AMENDMENT TO THE

PIKE RIVER WATERSHED PLAN

KENOSHA AND RACINE COUNTIES

REPORT ON REFINEMENTS MADE TO THE PIKE RIVER WATERSHED PLAN IN CONJUNCTION WITH THE ENVIRONMENTAL IMPACT STATEMENT PROCESS

REFINED RECOMMENDED FLOOD CONTROL AND PARKWAY PLAN FOR THE UPPER PIKE RIVER

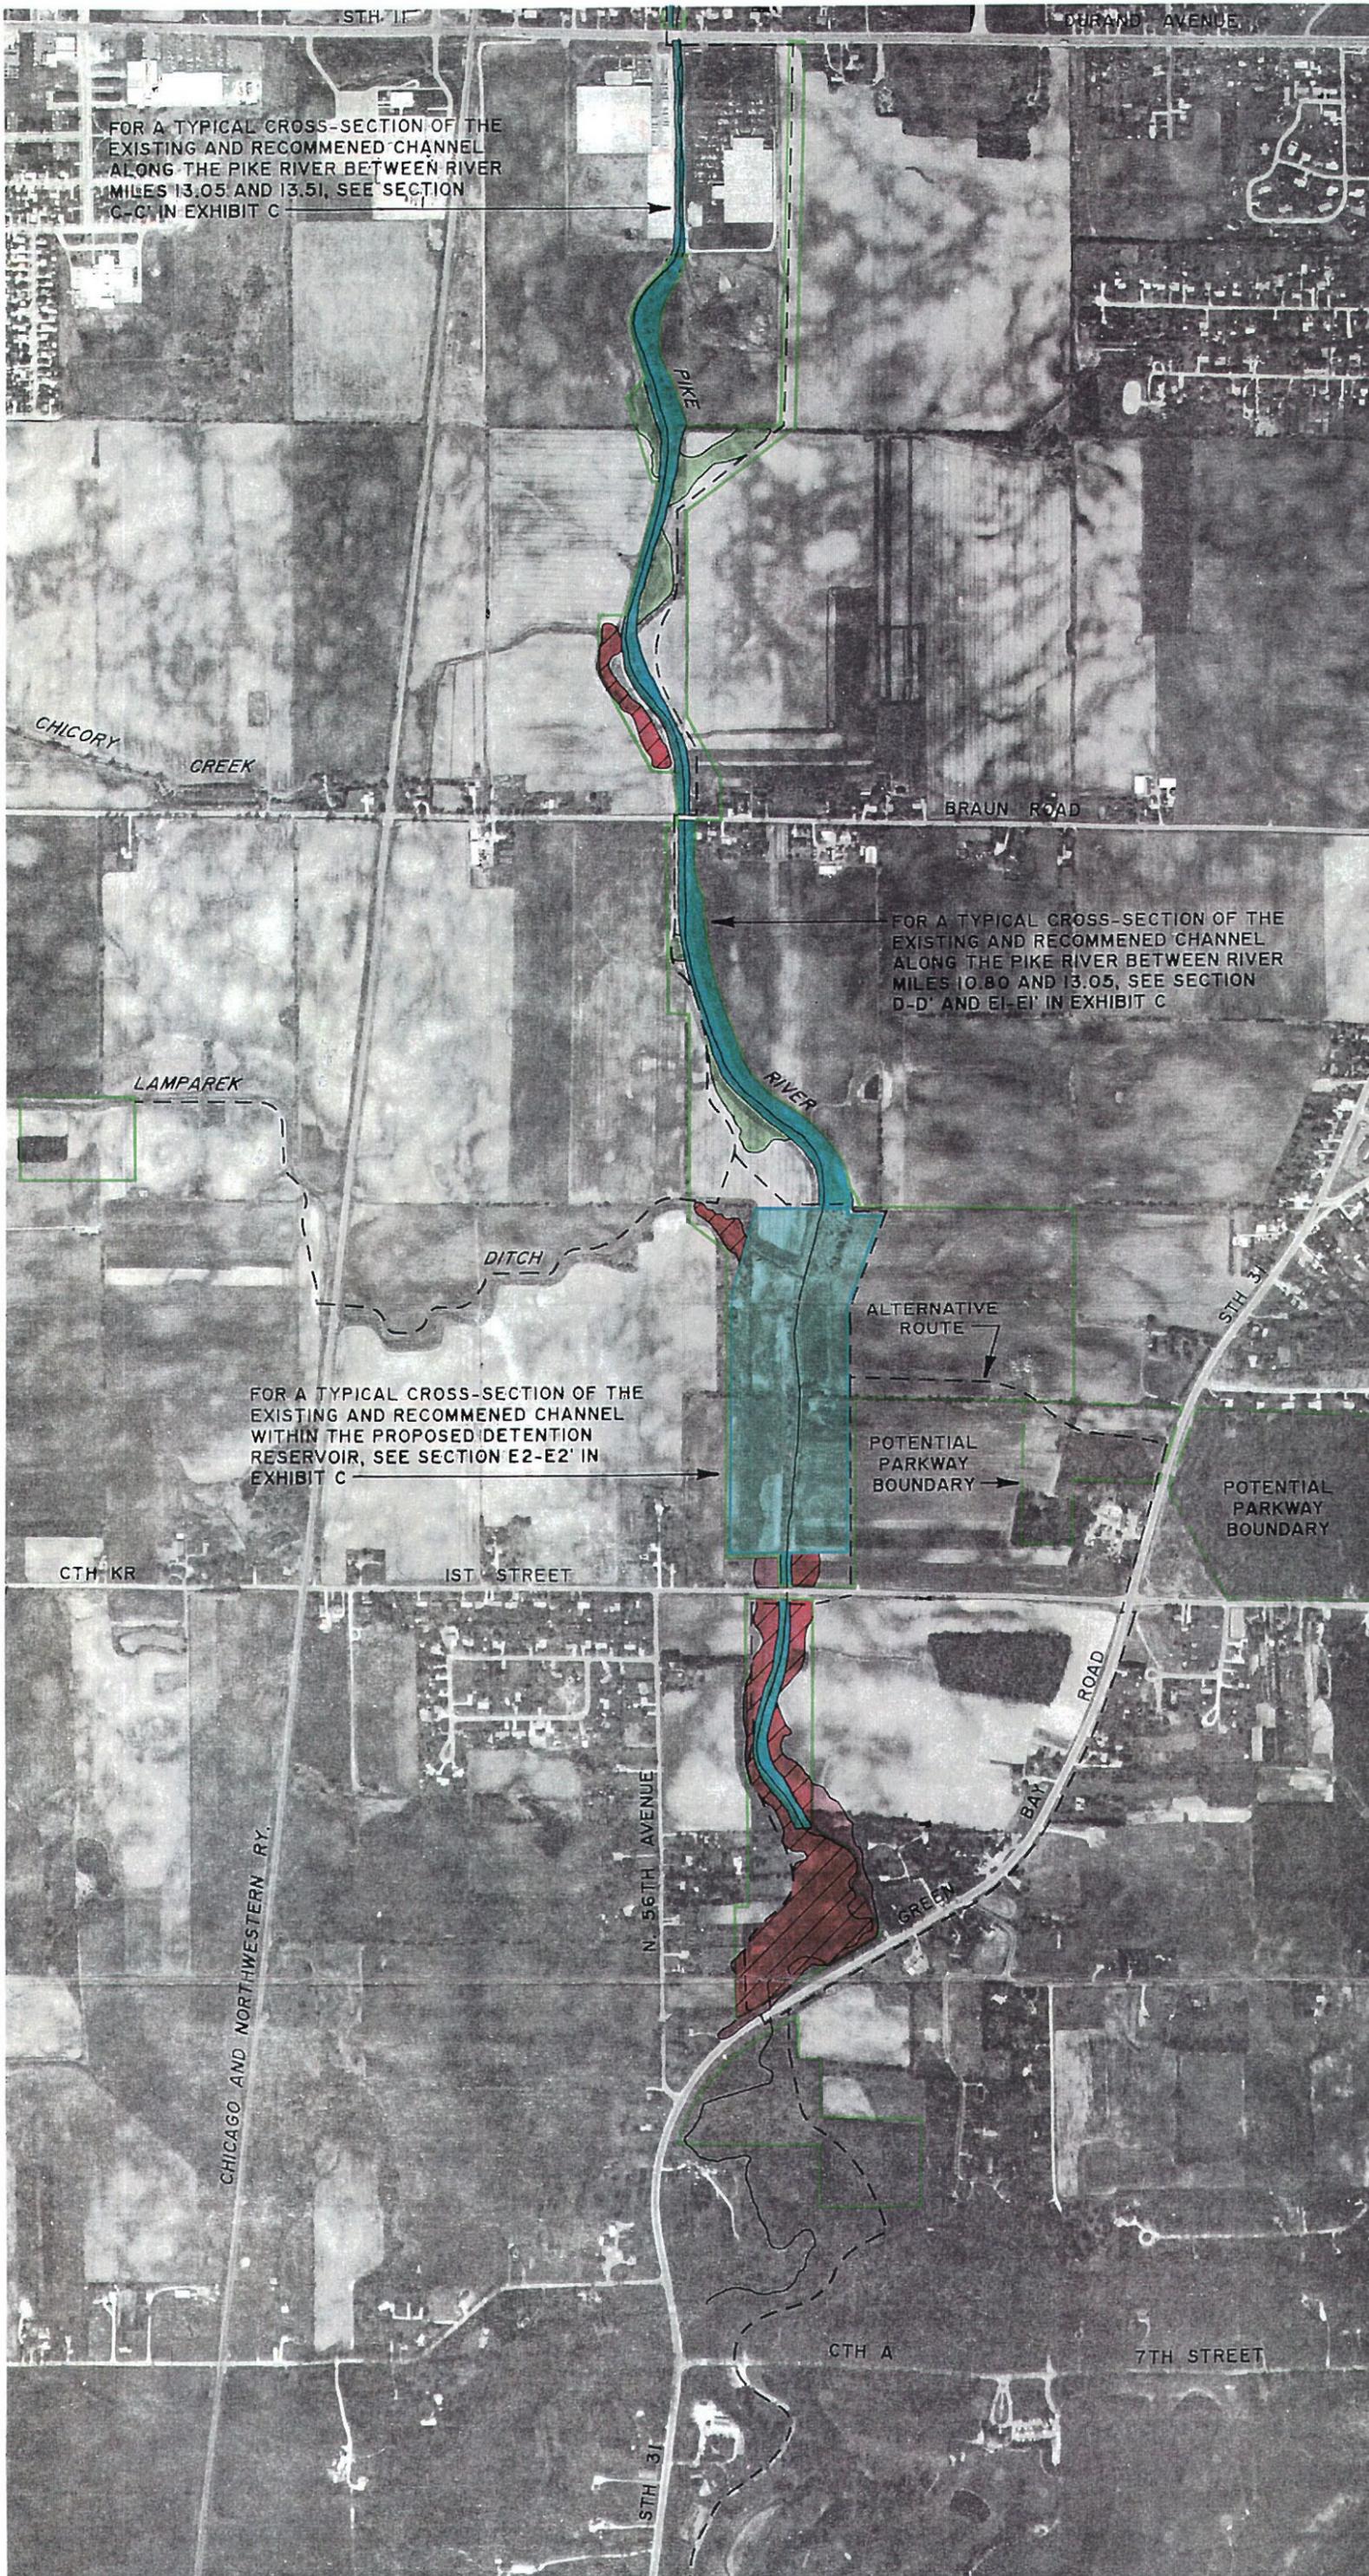
A preliminary delineation was also made of the boundaries of a Pike River parkway called for under the park and open space plan for the Town of Mt. Pleasant. This parkway is intended to incorporate the proposed improved Pike River channel and adjacent 50- to 100-foot-wide buffers. Natural resource restoration areas were also incorporated into the proposed parkway. These areas are located adjacent to the channel and have been identified as having hydric soils or being residual floodplains. These areas would be restored to wetland or native upland grasslands. The channel and recreational trail alignments and the related parkway features are shown on Exhibit A.

A reach-by-reach description of the proposed channel refinements for the Pike River is presented below.

The proposed flood control channel and streambed cross-section would remain as developed by Crispell-Snyder, Inc. The channel would have a bottom width ranging from 20 to 34 feet and side slopes ranging from one on two to one on four. The channels, which are basically trapezoidal in cross-section, would have rounded corners and a natural appearance.

TYPICAL CROSS-SECTION OF PROPOSED LOW-FLOW CHANNEL

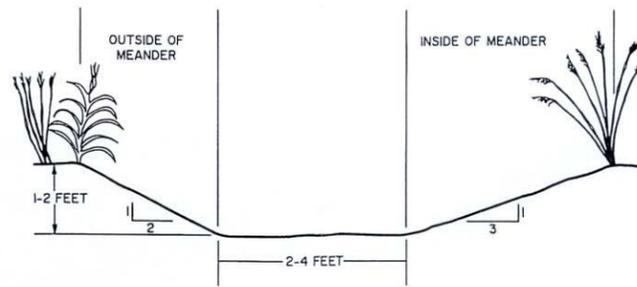
A low-flow channel would be located within the flood control channel. This low-flow channel would have a depth varying up to two feet, a bottom width of two to four feet, and side slopes ranging from one on one to one on three feet. The channel would be designed with alternating meanders and runs along the bottom of the flood control channel. Meanders would be located anywhere from five to fifteen channel widths apart, about 50 to 200 feet, with an overall length which is at least 1.5 times the length of the corresponding flood control channel. Those meanders are intended to promote development of alternating pool and riffle areas within the low-flow channel. Additional structures, such as drop sills and wing deflectors, would also be incorporated into the low-flow channel as necessary. The location of those measures would be identified on a site-specific basis as part of an overall habitat design. A rock or gravel substrate would also be added at selected locations along the channel to provide spawning areas. A typical cross-section of this low-flow channel is shown in Exhibit B.

TYPICAL CROSS-SECTIONS OF EXISTING AND PROPOSED CHANNEL ALONG THE UPPER PIKE RIVER

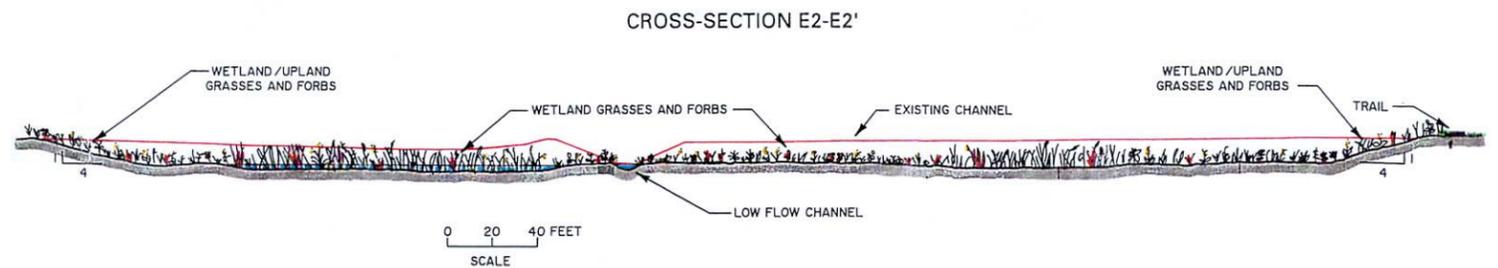
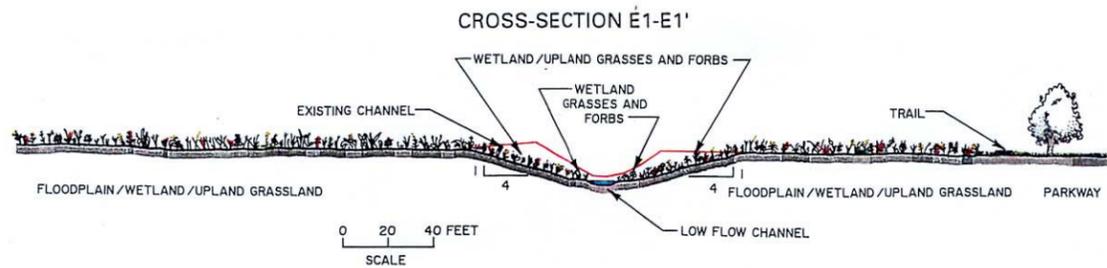
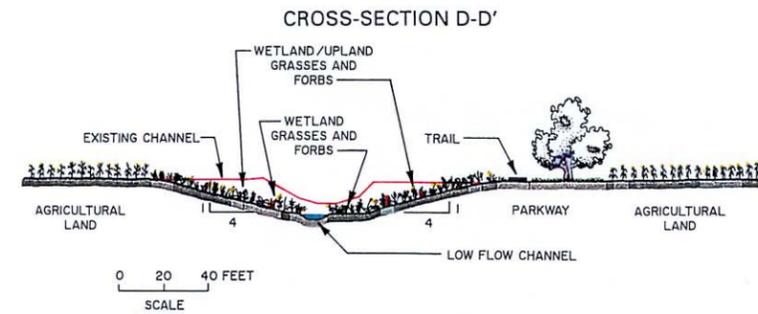
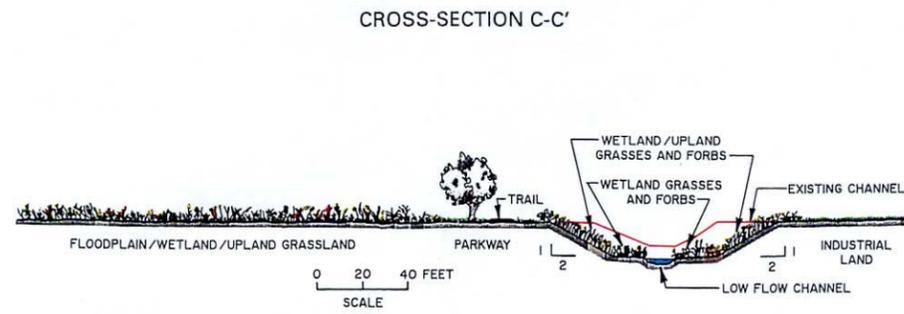
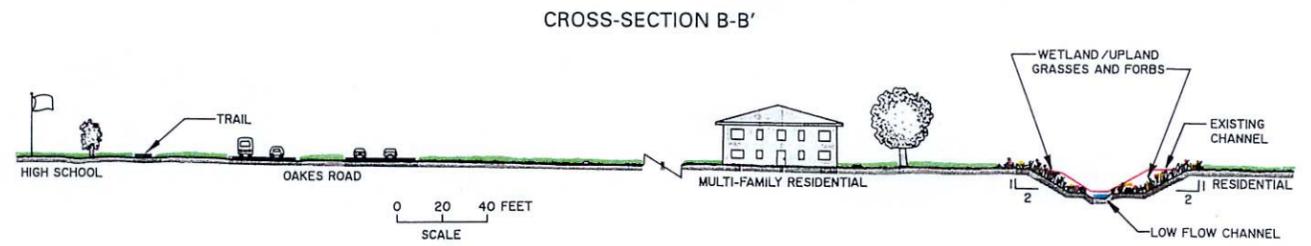
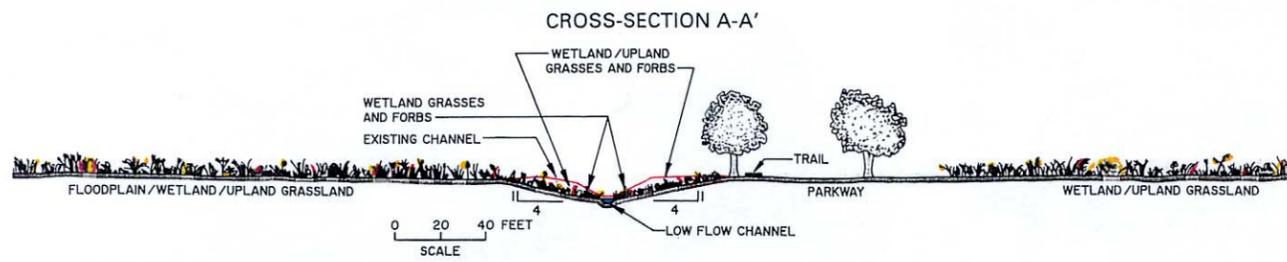
Cross-section A-A' on Exhibit C illustrates the proposed channel for this stream reach.

Cross-sections B-B' and C-C' on Exhibit C illustrate the proposed channel for this stream reach.

The channel modifications proposed for the Upper Pike River may be expected to increase downstream flood flows and stages over existing channel conditions. This would require that proper legal arrangements, usually flood easements, be obtained from all property owners affected by the increase. In order to avoid this increase in flows and stages, additional floodwater storage would be provided by enlarging the flood control channel along an approximately 2,350-foot-long reach beginning 250 feet upstream of CTH KR. This storage facility would extend through the site of a proposed community park to be located at the confluence with Lamparek Ditch. The added storage provided would serve to limit downstream flood discharges and attendant stages to year 2010 planned land use and existing channel condition levels. A total storage volume of about 400 acre-feet would be required at this location during a 100-year recurrence interval flood event. Cross-section E2-E2 on Exhibit C illustrates this floodwater storage basin.

REFINED RECOMMENDED FLOOD CONTROL AND PARKWAY PLAN FOR PIKE CREEK, AIRPORT BRANCH, AND THE TRIBUTARY TO AIRPORT BRANCH

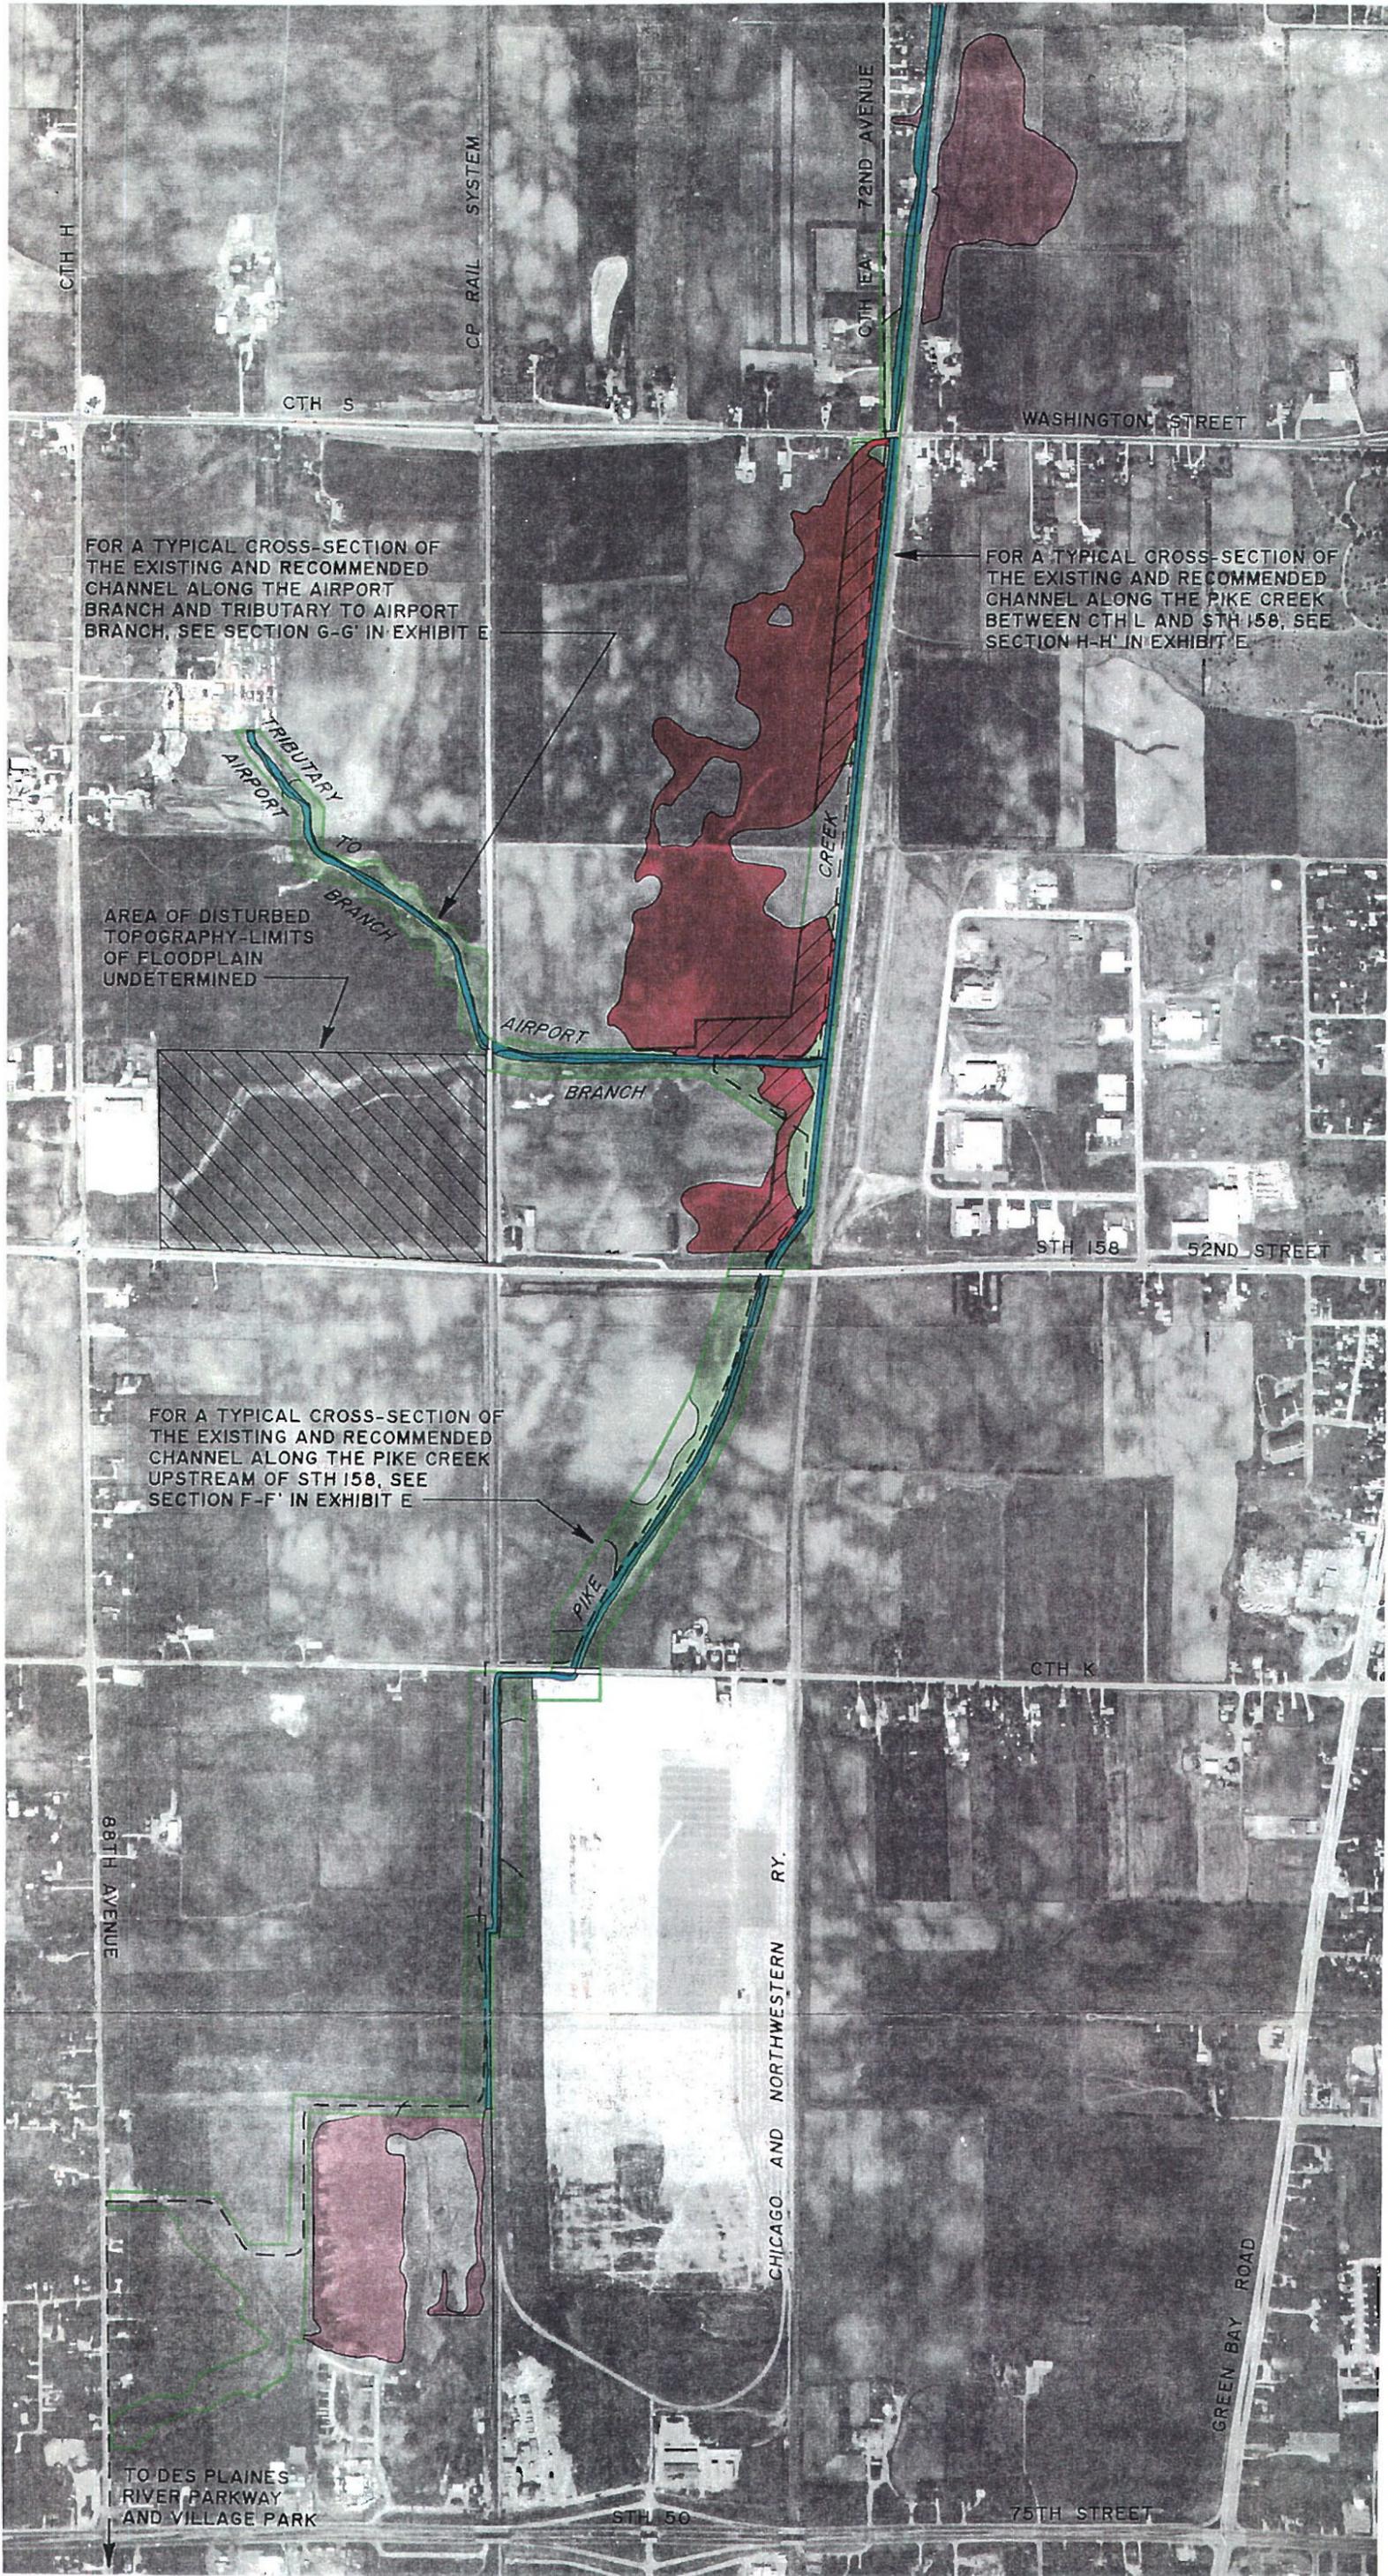
A preliminary delineation was also made of the boundaries of a Pike Creek parkway, which would connect Petrifying Springs Park with a proposed community park located in the Village of Pleasant Prairie. This parkway is intended to incorporate the proposed improved Pike River channel and adjacent 50- to 200-foot-wide buffers. Natural resource restoration areas were also incorporated into the proposed parkway. These areas are located adjacent to the channel and have been identified as having hydric soils or being residual floodplains. These areas would be restored to wetland or native upland grasslands. The channel and recreational trail alignments and the related parkway features are shown on Exhibit D.
